V2500 Propulsion System — Nacelle

# SERVICE BULLETIN

NACELLE — POWERPLANT — BOLTS, PYLON APRON, — REPLACEMENT OF

V2500-NAC-71-0209

Replace the Pylon Apron Bolts - Left Nacelle  
Figure 1 (sheet 1)

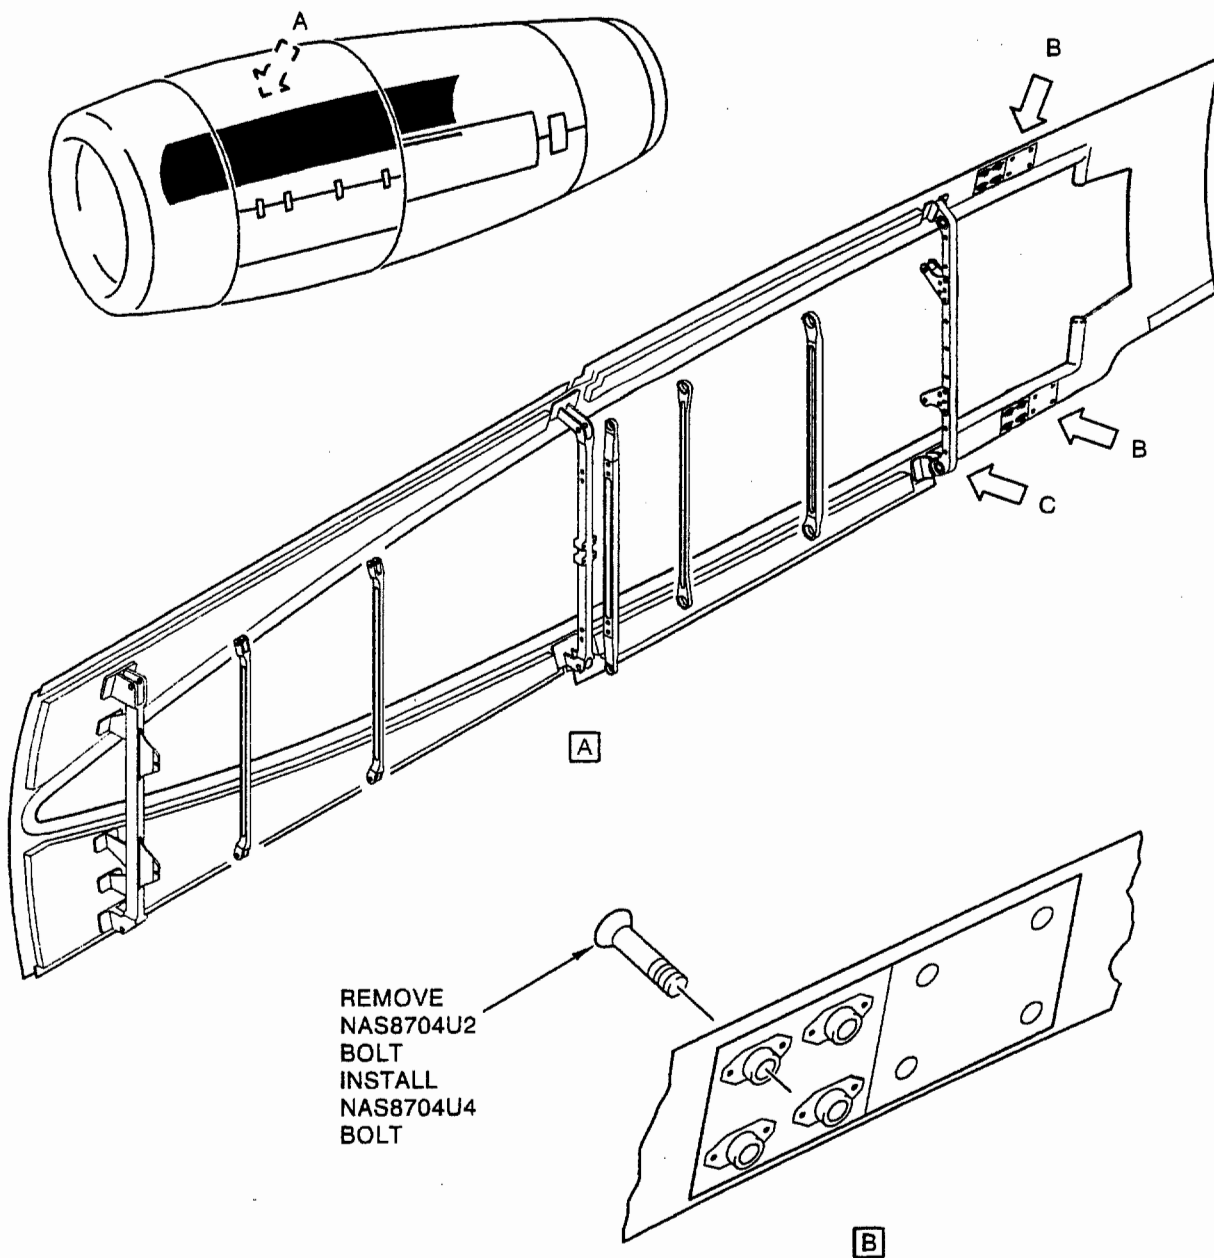
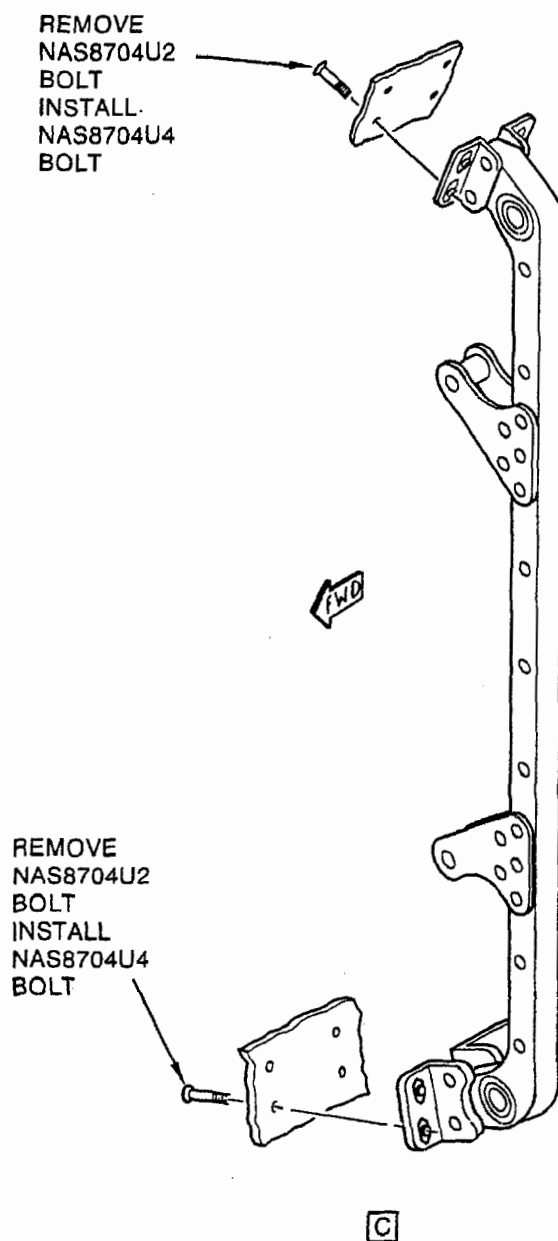
(1) Remove the NAS8704U2 bolts. Refer to Figures 1 and 2.

(2) Install the NAS8704U4 bolts. Torque the bolts to 63 to 70 lbfin (7.1 to 7.9 Nm). Refer to Figures 1 and 2.
